Rudder pedal crank substitution and positioning

Mandatory.

All fuselage kits delivered before issue of this modification.

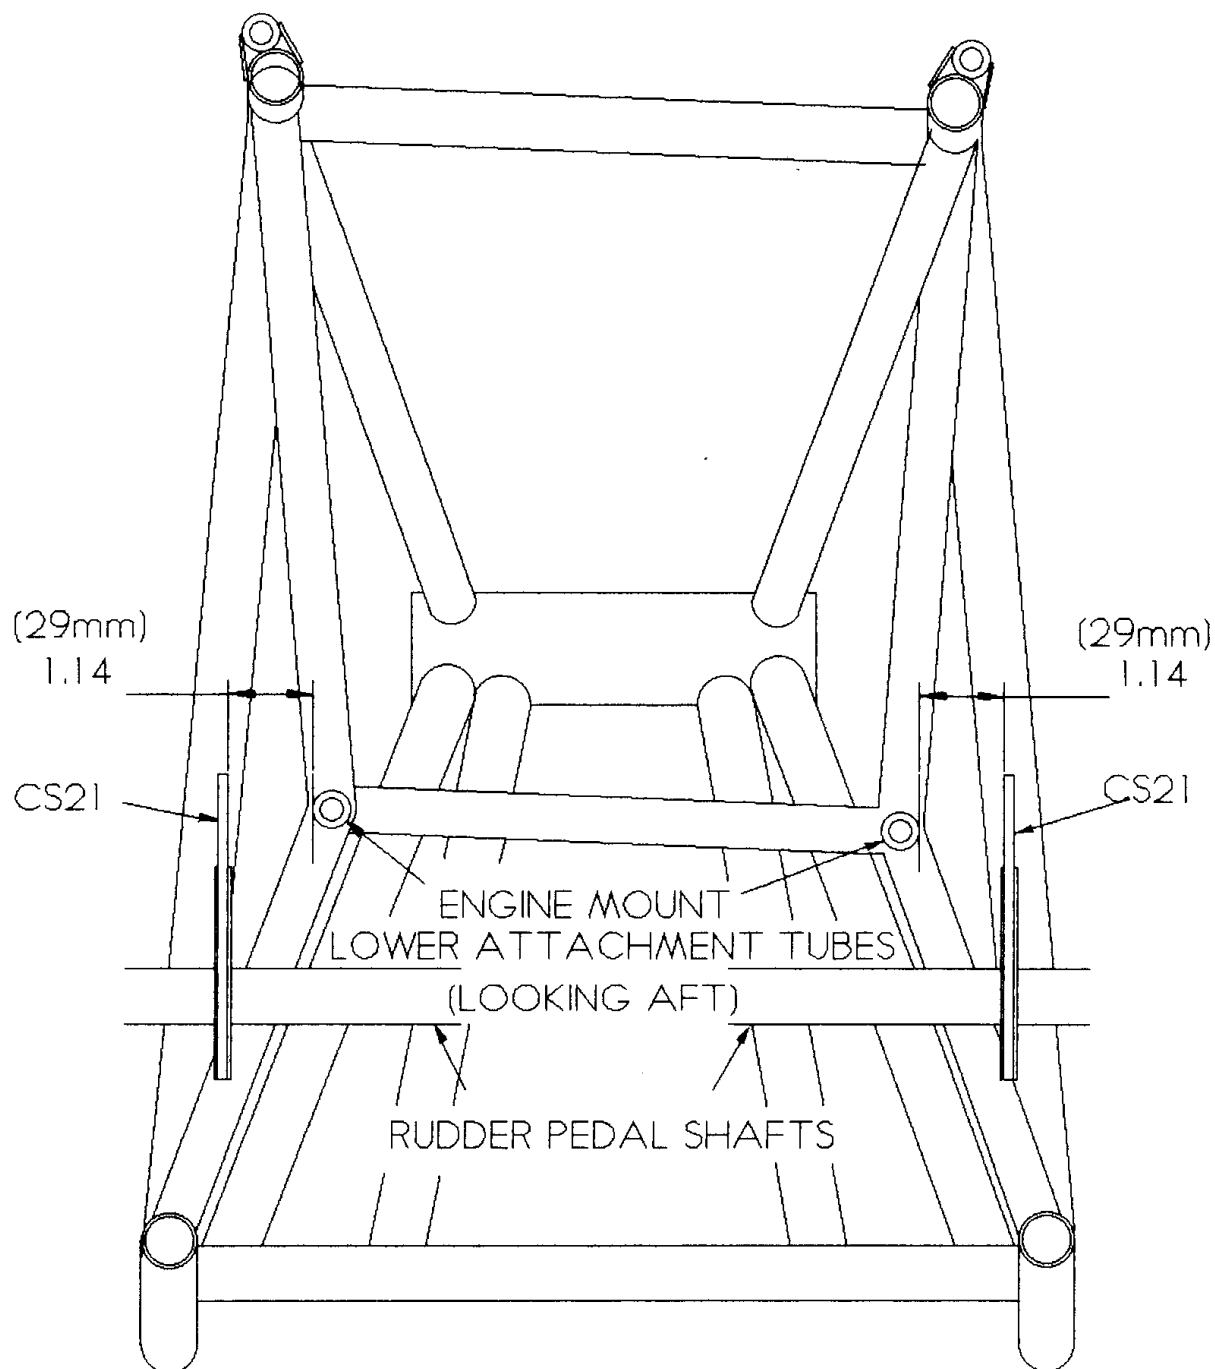
Due to potential corrosion occurring between the light alloy CS21 and steel rudder pedals, it is necessary to substitute them with steel CS21s. These are provided by Europa Aviation Ltd.

There have been problems reported associated with the positioning of the rudder pedals and therefore the CS21 rudder cable cranks. The problem does not arise until the Rotax engine mounting is fitted where, more often than not, there is interference between CS21 or the bolt holding the cable thimble and the lower shock mount housing of the engine mount. The manual has not supplied precise enough information to avoid this problem and several independent solutions have been found, some of which are not acceptable. There should be no need to bend the CS21 crank. The correct position of CS21 is shown in the figure overleaf.

The resulting position will provide clearance for the CS21 arms and the top bolt/cable thimble with the engine mounting. However, the cable will be very close to the Landing Gear frame and even touch it at some point of rudder pedal travel. This contact is remedied by the addition of the Tufnol rubbing strips as detailed at the end of the rudder pedal installation chapter.

If you have already installed your rudder pedals and the relative positions of LG frame and CS21 are not shown in the figure, unbolt the two halves of the pedals and, having substituted the light alloy CS21 with the new steel CS21, move CS21 as required until it is as shown in the figure.

The inner pedal's position is fixed so you will only be able to move CS21 outboard, pushing the outer pedal outboard with it. If the gap between CS21 and the inner pedal end plate is less than 13mm, then add steel shims or a steel block which is the same shape as the end plate itself. If the gap is greater than this, the inboard pedal mounts will have to be repositioned, necessitating removal of the rudder pedal floor panels to do this.

If required, to further increase clearance between the engine mount and the bolt holding the cable thimble at the top of CS21, it is permissible to substitute the AN525-10R6 bolt and AN970-3 washer with an AN24694-S58 bolt and a Tinnerman type washer.

Do not use a set screw (threaded all the way to the head) as the stresses would pass through the thread and not the plain shank of a bolt.
